1 May 2020

**SECTION 4.55(1A) MODIFICATION APPLICATION TO SSD 16\_7919  
85 CARABELLA STREET, KIRRIBILLI**

This application has been prepared by Ethos Urban on behalf of Loreto Kirribilli, pursuant to section 4.55(1A) of the *Environmental Planning and Assessment Act 1979* (EP&A Act) to modify the Concept Proposal and Stage 1 Development Consent (SSD 16\_7919) relating to 85 Carabella Street, Kirribilli (the site).

**Figure 1 Approved roof layout (left) and proposed roof layout (right)**

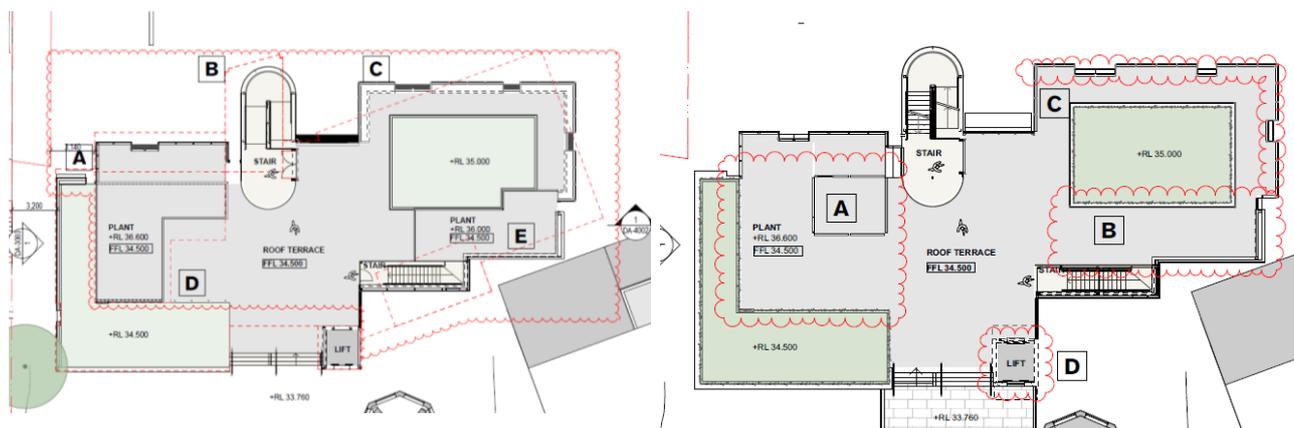
- A significant reduction in the extent of the roof top plant zone at the western end of the roof and removal of the roof top plant from the eastern side of the roof, as shown at **Figure 1**. The reduction in roof top plant is possible due to the rationalisation of services and the proposed changes to the extent of excavation, which will enable more services to be located below ground and at the Ground Level driveway, away from neighbouring properties. This will result in improved visual impacts and better amenity for neighbouring properties, as discussed at **Section 4.3.1**.

- A minor change to the configuration of the landscaped zone at the eastern end of the roof as a result of the plant being removed (refer to **Figure 1**). This part of the roof will continue to be non-trafficable.

**Figure 2 Photograph of fill on-site**

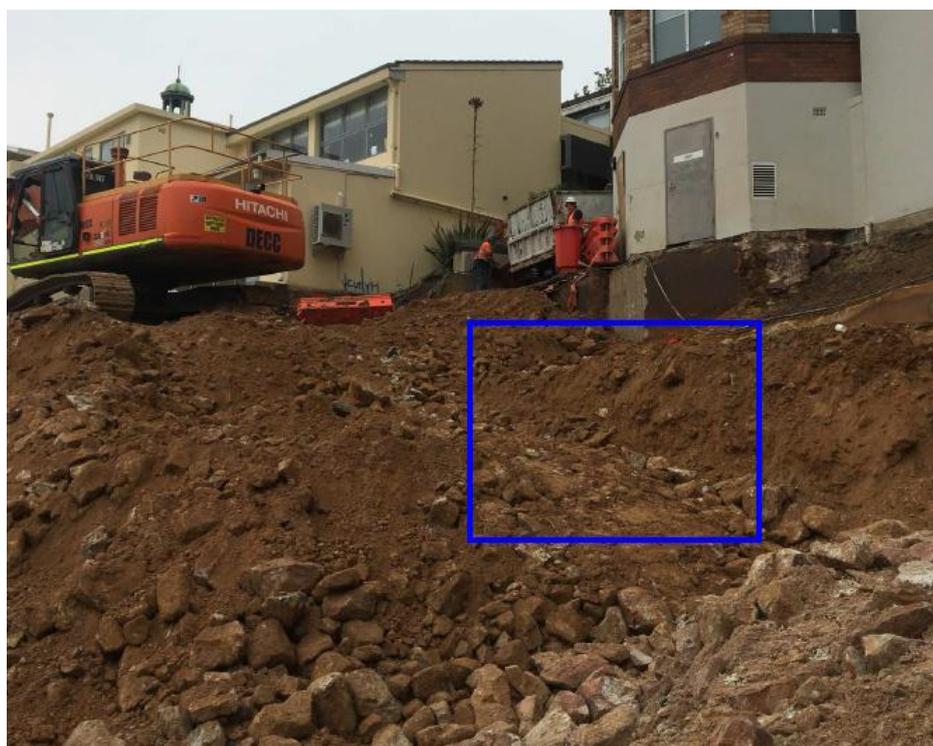
A minor increase is proposed to the extent of excavation. The changes are largely a result of ground conditions on-site, with inconsistent rock and fill quality leading to some areas of fill falling away during the excavation process (refer to photo at **Figure 2**). Minor additional excavation is also required to accommodate minimum clearance for excavation machinery.

**Figure 3 Approximate location of the proposed substation shown in grey**

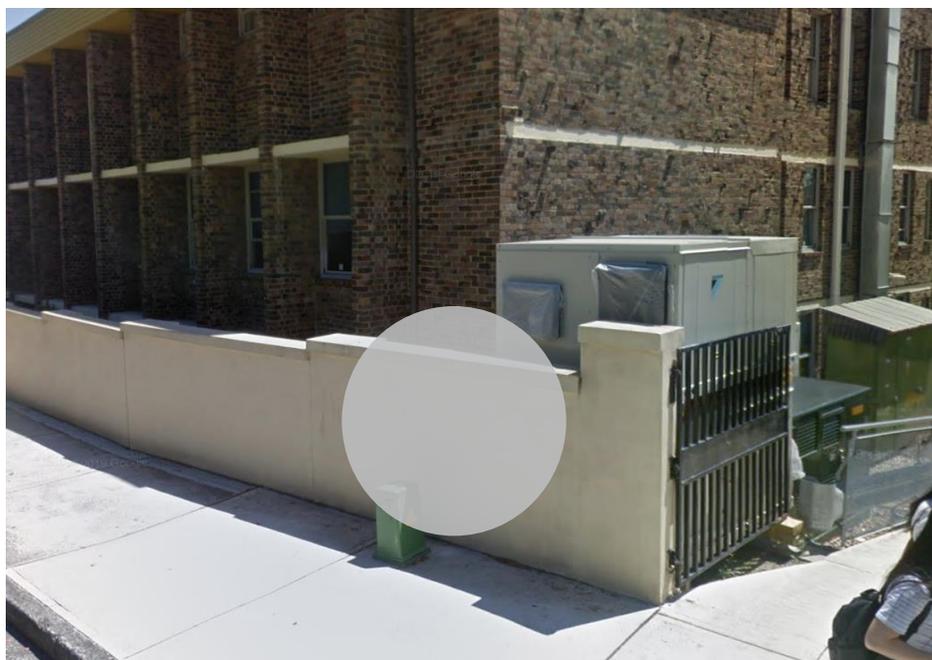
The substation will be constructed on a suspended slab, on a 5.3m x 2.05m easement. Installation of the substation will require an existing pillar and a small part of the rendered wall fronting Carabella Street to be removed (**Figure 3**). The substation will be recessed to sit in-line with the wall, which will be reconstructed to match the existing. The new retaining wall around the sides and rear of the proposed substation will be constructed of reinforced concrete 'block' to prevent any blast from the substation impacting the school. Plans of the proposed substation and surrounding structure have been prepared by JHA Consulting Engineers and Michael Eil Consulting Engineers respectively, and are both provided at **Appendix B**.

**Table 3** Northern Visual Impact (SSD approved building outlined in red, MOD 1 approved outlined in green, proposed outlined in blue)

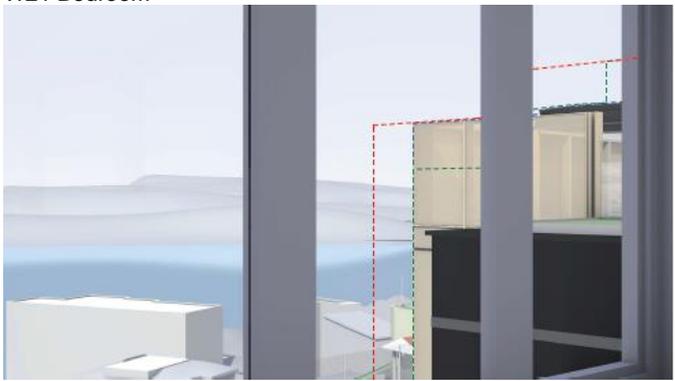
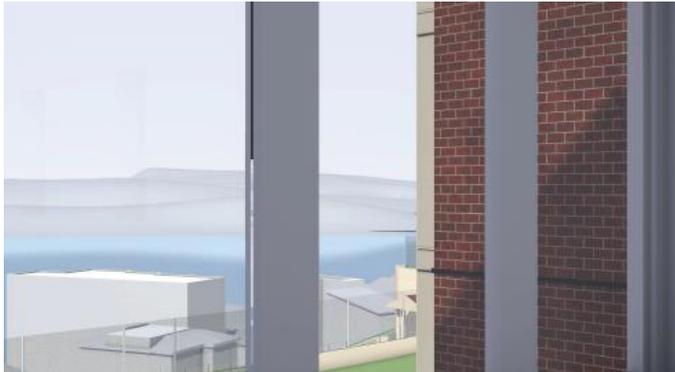
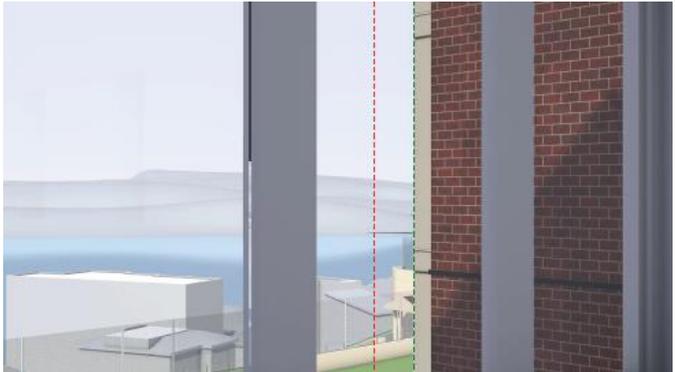
**Table 3** compares the views from W21 and W22 (bedrooms), taken from a worst-case viewpoint looking obliquely across the school site. The comparison shows that the proposed amendments will not result in any significant changes to views from the northern apartments in 111 Carabella Street.

The comparison shows the increased height of the façade in the north-western corner of the building (outlined in blue). Whilst the façade is higher than that approved under MOD 1 (outlined in green), it remains consistent with the height of the original SSD approval (outlined in red). The modified façade will result in a small loss of sky views when viewed from the top-floor apartment, however the outcome still represents an improvement when compared to the originally approved design. The reduction in the extent of the roof top plant will also result in a small increase in sky views, when compared to the approved development.

**Table 4** Additional Views (MOD 1 approved building outlined in green, proposed outlined in blue)

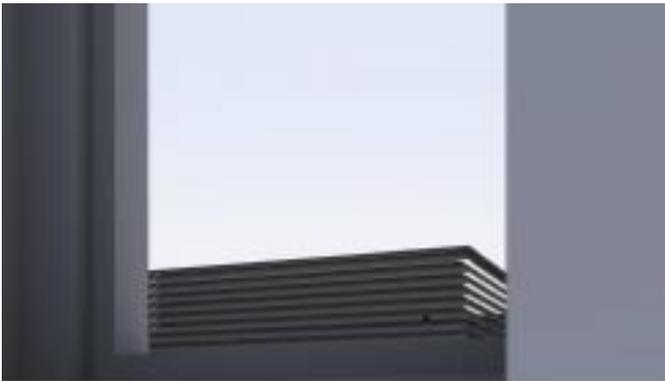
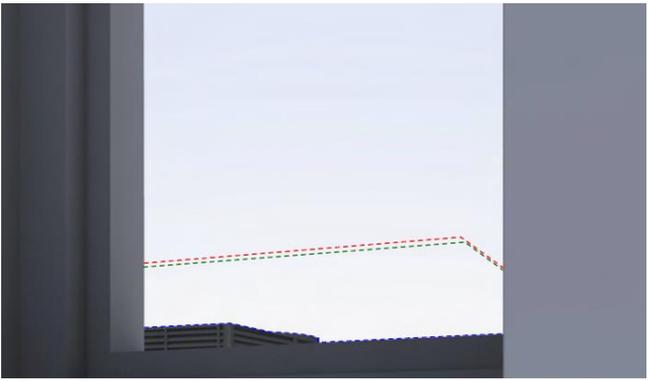
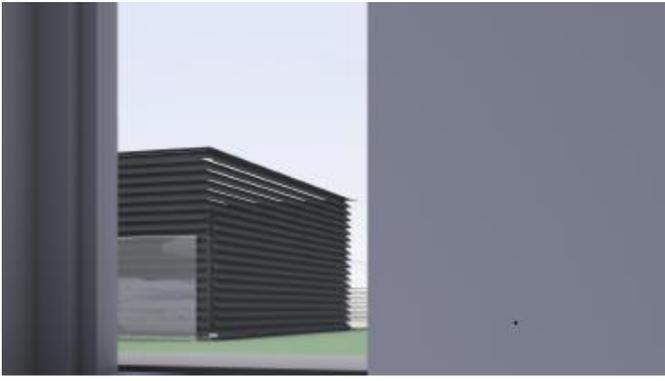
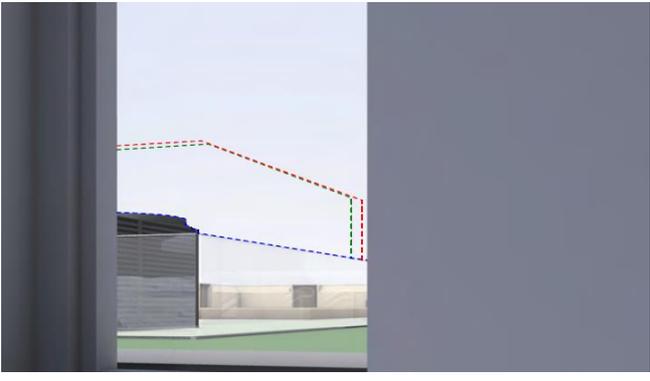
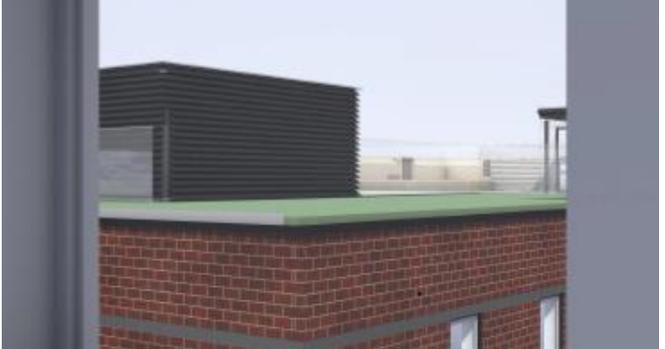
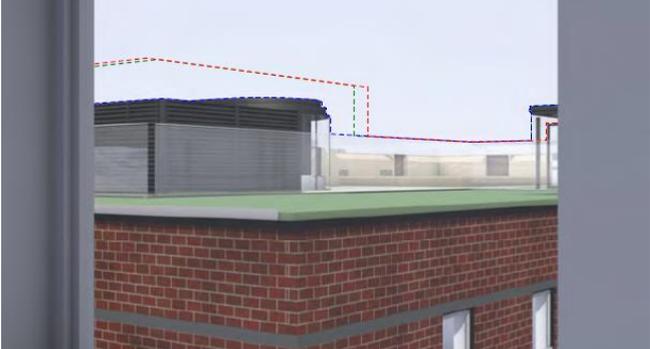
In addition, FJMT has taken a series of additional views to show the full extent of the improvements resulting from the reduction to the roof top plant (refer to **Table 4**). These views do not comply with the Land and Environment Court methodology and so do not form part of the formal visual impact assessment, however they have been provided to show the significant improvement in outlook and sky views that will be achieved from east facing apartments in 111 Carabella Street as a result of the proposed modifications.
